**Re: Response to Comments from Conservation Agent, EcoTec and Mass DEP
Timber Crest Estates Development, Medway, MA (DEP File #216-914)**

Goddard Consulting, LLC is pleased to submit this letter in response to the comments received regarding the Notice of Intent for the Timber Crest Estates residential development in Medway, MA. Responses are provided for the following comment sources:

Figure 1 - CAPS map of project vicinity.

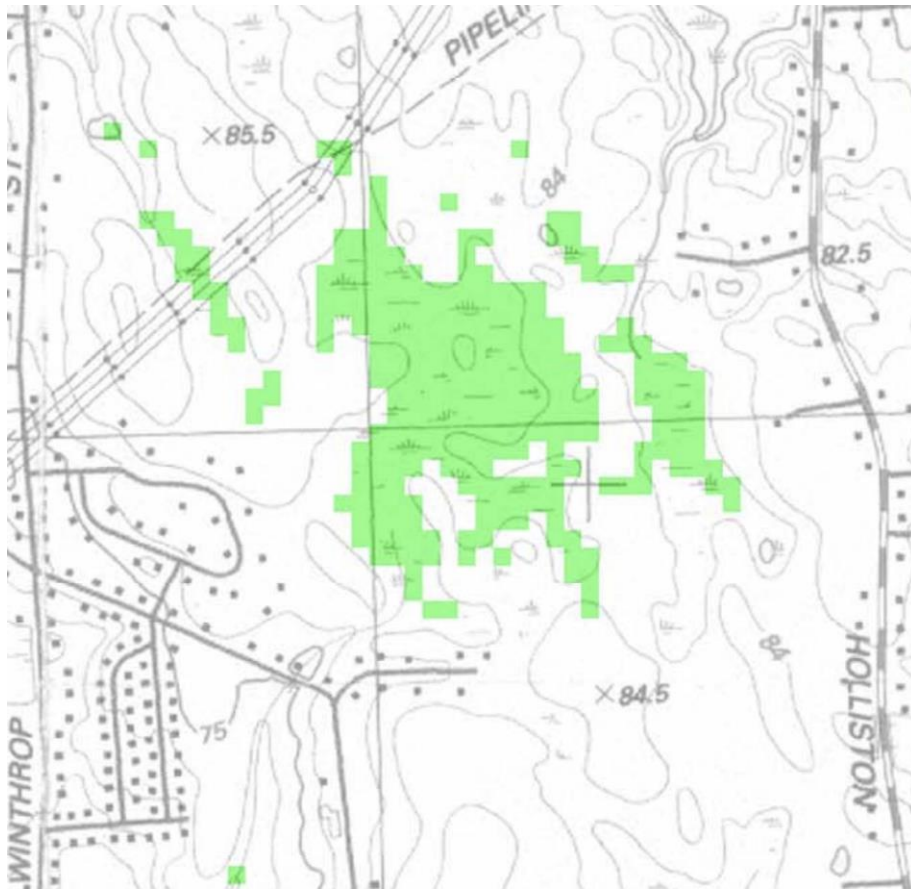
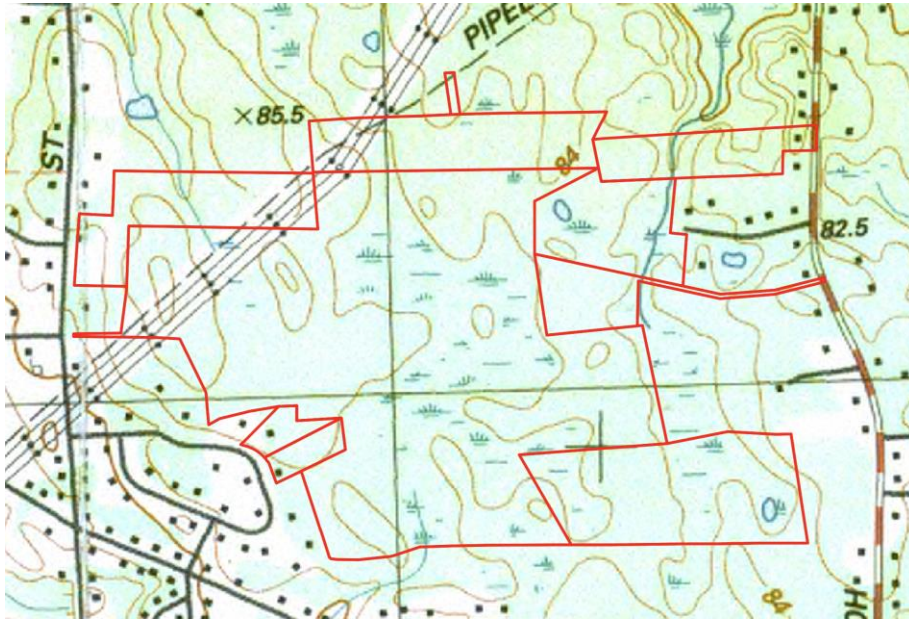
It should be noted that 0-R Woodland Road and portions of the adjacent parcels are identified on the CAPS mapping (Conservation Assessment and Prioritization System). See Map. This system assesses the ecological integrity of the lands and waters subsequently identifying and prioritizing land for habitat and biodiversity.

We agree that the onsite areas mapped by the CAPS program (see Figures 1 & 2 below) contain valuable habitat for a variety of wildlife. Most, if not all of, the mapped area will remain undeveloped.
